SUBJECT: Forwards updated responses to Seismic Review Team & Pump & Valve Operability Review Team audit open items. Util currently performing compliance & verification review of seismic qualification program.

Re: Nine Mile Point Unit 2  
Docket No. 50-410

Enclosed for your information are certain updated responses to the Seismic Review Team and Pump and Valve Operability Review team Audit open items for Nine Mile Point Unit 2. Ten copies of the following information are provided:

FIGURE 1  
SOLE PLATE PREGROUTING DEVICES

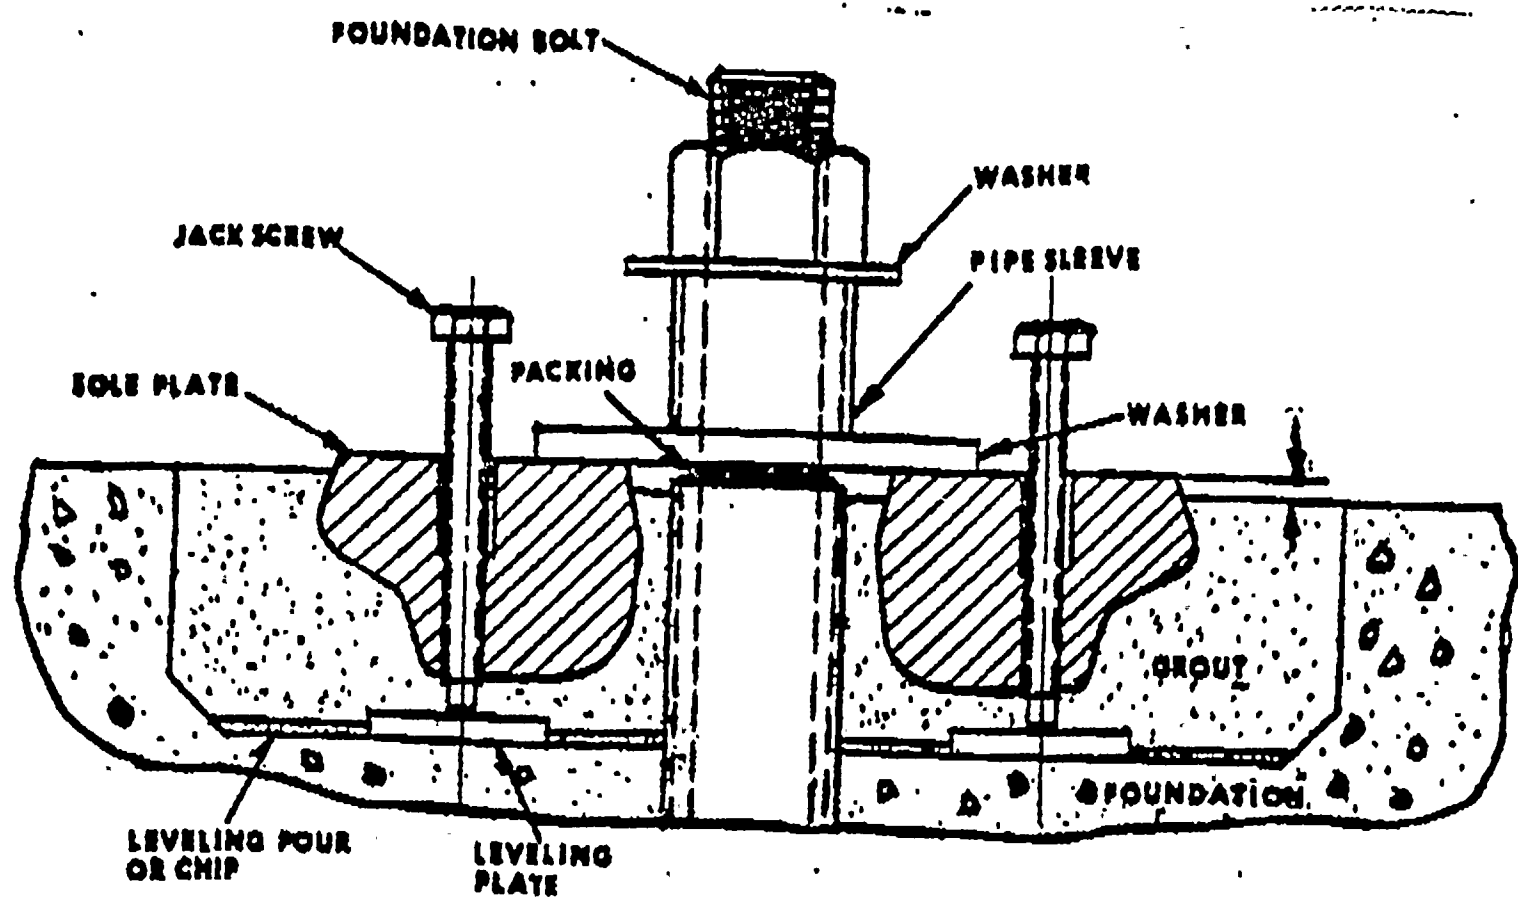
The use of loose shim plates in mounting the generator skid was not justified.

A review of the foundation drawing for installation of the generator skid (Cooper Bessemer Drawing No. KSV-97-16) found no loose shim plates specified for the generator mounting.

There appears to be a misunderstanding in terminology used. The above-referenced drawing refers to a sole plate which is placed on top of the grout, under the bottom washer of the foundation bolts (see attached sketch). The bolts were torqued to the specified value, and the sole plate was set and level in accordance with SWEC procedure SC-28-12, as verified and documented in the QC inspection report that was presented during the audit.

The installation drawing referenced above does not call for any shim plates to be used in the installation of the generator skid, and none were used as verified by field walkdown.
